**NEW YORK STATE DEPARTMENT OF
ENVIRONMENTAL CONSERVATION**

**ORDER ON CONSENT
and
ADMINISTRATIVE
SETTLEMENT**

Site # 360015

Map of Areas of Concern ("AOCs")

FIGURE 6

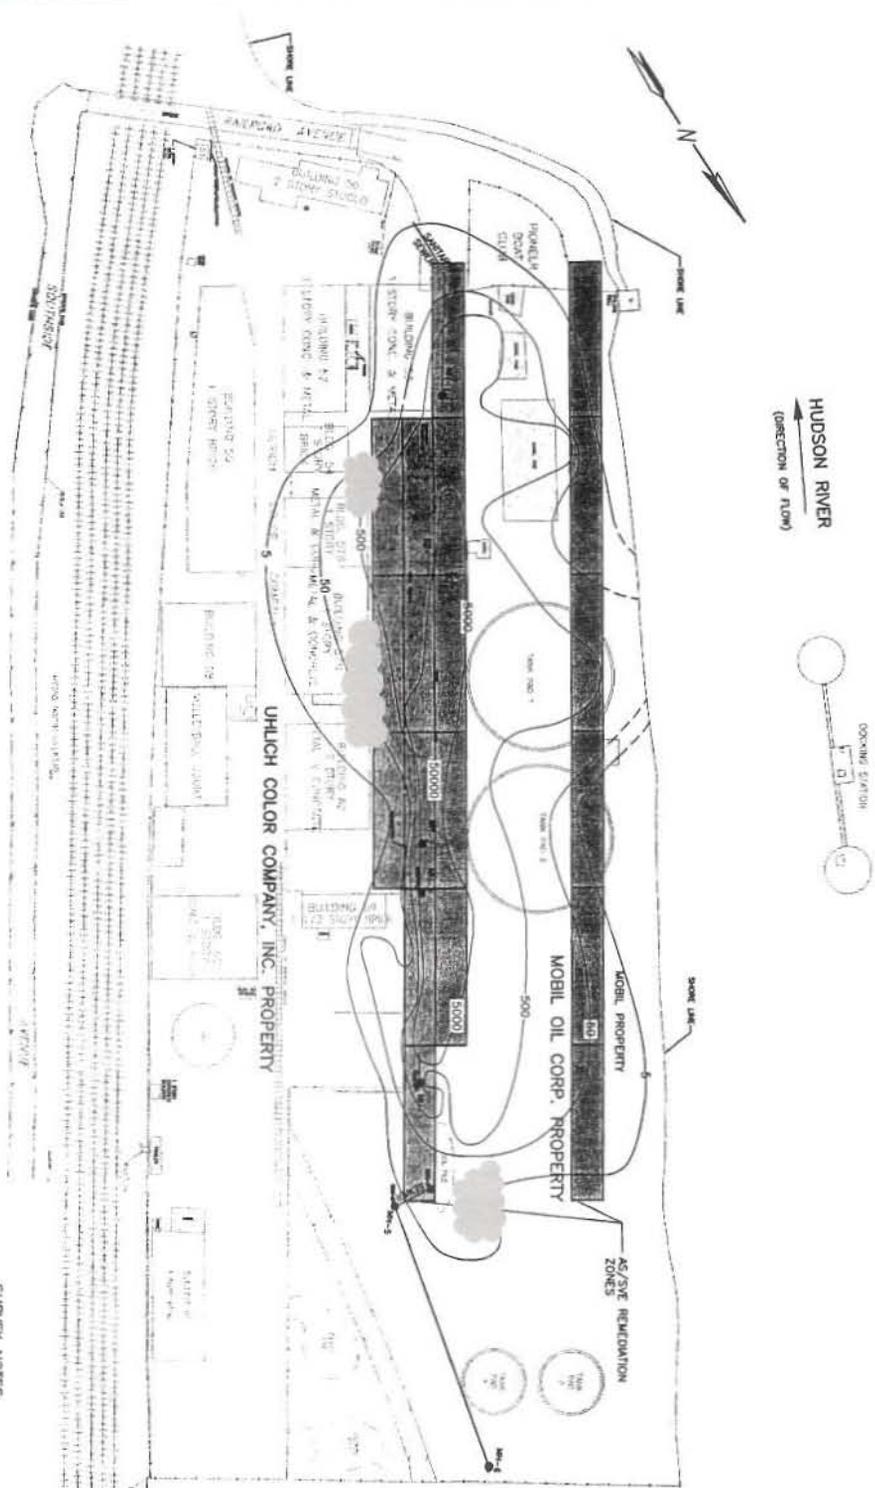
Comment 33: As outlined in the PRAP, the selected soil remedy includes the excavation and off-site disposal of "grossly contaminated soils" related to residual petroleum identified on the former Mobil Tappan Terminal. Figure 6 of the PRAP depicts the proposed location for the completion of this soil excavation. The PRAP does not provide information on the deciding factor in determining grossly contaminated soils or the extent of the area to be evaluated for the presence of grossly contaminated soils.
